Access Compliance Report

Public Rights-of-Way

(Curb Ramps)

Intersection ID: 8181	Main Street: FREEDOM_DR	Cross Street: TODDVILLE_RD	Location: SW
ADA ID: B166EA0DCD95	Ramp Type: Perp	Initial Pass/Fail: Fail	Overall Compliance: No
Severity Score: 12.5			
Codes/Mitigation Info/Possible Solution		Field Measurements/Component Compliance

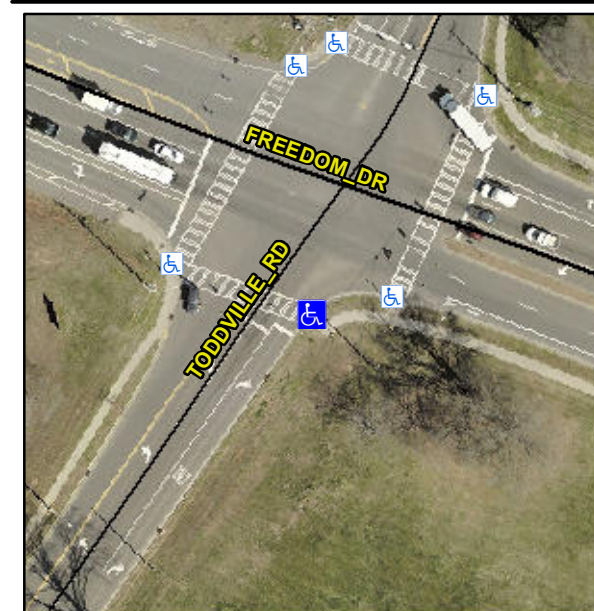
Not Found, R304.2.2

Compliance	Description	Data	Compliance	Description	Data
N/A	Ramp Length (in)	84.0	No	Ramp Slope (%)	8.4
Yes	Ramp Width (in)	48.0	Yes	Ramp XSlope (%)	0.0
N/A	Flare Type LT	N/A	N/A	Flare Type RT	N/A
N/A	Flare Slope LT (%)	N/A	N/A	Flare Slope RT (%)	N/A
N/A	Flare Traversable LT?	N/A	N/A	Flare Traversable RT?	N/A
N/A	Landing Length (in)	N/A	N/A	DWS Provided?	N/A
N/A	Landing Width (in)	N/A	N/A	DWS Contrast?	N/A
N/A	Landing Slope (%)	N/A	N/A	DWS Length (in)	N/A
N/A	Landing X Slope (%)	N/A	N/A	DWS Full Width?	N/A
N/A	Landing Curb? (Y/N)	N/A	N/A	DWS Offset (in)	N/A
N/A	Shared Landing?	N/A			
N/A	Gutter Ponding?	N/A	N/A	Gutter Slope (%)	N/A
N/A	Gutter Lip Ht (in)	N/A	N/A	Gutter X Slope (%)	N/A
N/A	Painted X Walk1?	Yes	N/A	Painted X Walk2?	N/A
	X Walk 1 Direction	To NW		X Walk 2 Direction	N/A
N/A	X Walk 1 Width (in)	112.0	N/A	X Walk 2 Width (in)	N/A
	X Walk 1 Slope (%)	0.7		X Walk 2 Slope (%)	N/A
	X Walk 1 X Slope (%)	0.3		X Walk 2 X Slope (%)	N/A

Remove & Replace Entire Ramp.
